STATE OF WASHINGTON
DEPARTMENT OF ECOLOGY

Re: Long term groundwater monitoring frequency based on BIOSCREEN modeling of hypothetical contaminant travel times at the Landsburg Mine site in Ravensdale, Washington

Attachment A. Explanatory Notes on Ecology's decision for long term monitoring frequency based on the BIOSCREEN modeling

IV. Hypothetical Outcomes of Approaches Used To Derive Monitoring Frequencies Approaches

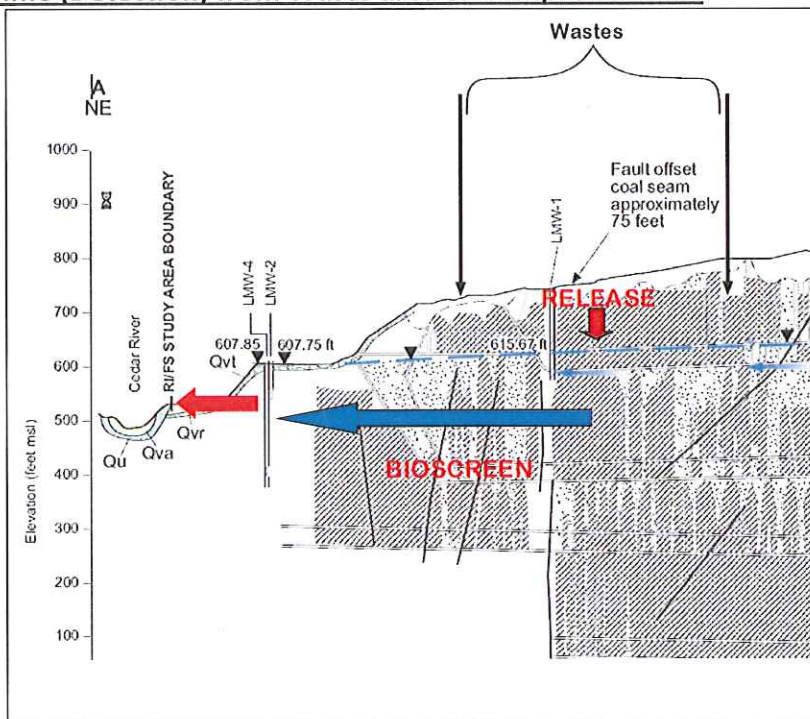
RESULT: No detection during 2nd round (month 36) and the plume will have traveled past well an additional 35 months before detection (past MDL) only on the 3rd round. Not an acceptable approach for long term groundwater monitoring.

RESULT: At 2nd round of sampling, well will not reach action level (0.5 CUL) required to trigger action although contamination will have been detected. Concentration will be >MDL but <0.5 CUL. It will be a 4 year old plume when the 3rd round of samples is taken. There is time for warning; however, since it occurs at compliance well, the time for corrective action will likely be short. Engenders the perception that upon detection, contamination will have progressed too far.

RESULT: At 2nd round of sampling, concentration at sentinel well will be >>0.5CUL (many orders of magnitude greater). The compliance well will be < MDL or nondetect. It will be a 5 year 9 month (5.72 years) old plume by the time the 2nd round of samples is taken. However, the plume will not have reached the compliance well locations. Substantial pre-warning will have occurred with sufficient time to mobilize a corrective action.
